**REQUEST** Current Zoning: N1-A (Neighborhood 1-A)

Proposed Zoning: N2-A(CD) (Neighborhood 2-A, Conditional)

**LOCATION**Approximately 19.54 acres located east of Mallard Creek Road, on the north and south side of Alexander Road, and along the west side of

**SUMMARY OF PETITION**

### Proposed Request Details

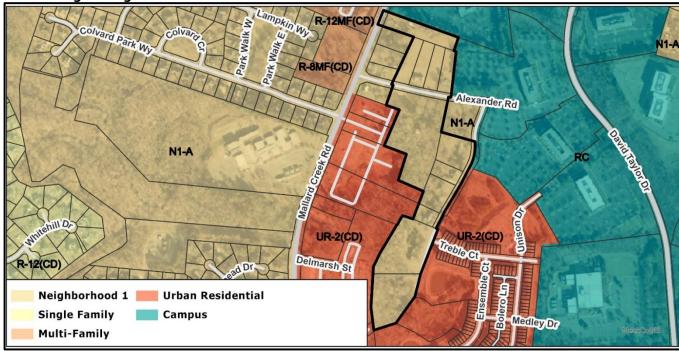
- 1. Revise roadway callouts to be U-03 and not U-03A1. U-03A1 is simply one part of the overall layout of U-03 while U-03 describes all of the U-03 cross sections required for this site.

- 2. Revise roadway callouts to be U-03 and not U-03A1. U-03A1 is simply one part of the overall layout of U-03 while U-03 describes all of the U-03 cross sections required for this site.

- 3. Add proposed ROW dimensions to the site plan for College View Lane and Alexander Road. Ensure ROW is dimensioned in relation to the roadway centerline.

- 4. Revise site plan by revising callout to say final design of Treble Court connection to College View Lane to be coordinated during permitting.
- 5. Revise roadway identifier on the site plan to callout roadway as proposed, due to this not currently existing.

- 6. The existing R/W does not exist connecting to Silver Branch road. Label that the R/W and street will be constructed and improved along the entire project boundary.

- 7. Label the 8' sidewalk and 8' planting strip on all public streets. Label the centerline and the distance from centerline to 2' behind the sidewalk as R/W.

- 8. Ensure that tree save meets all standard. Tree save has a 10' no build zone around it and does not permit sidewalks within tree save.
- 9. Some areas shown as tree save do not have any trees. Adjust tree save areas to include existing canopy.

10. Clarify the provided seating requirements for public open space.
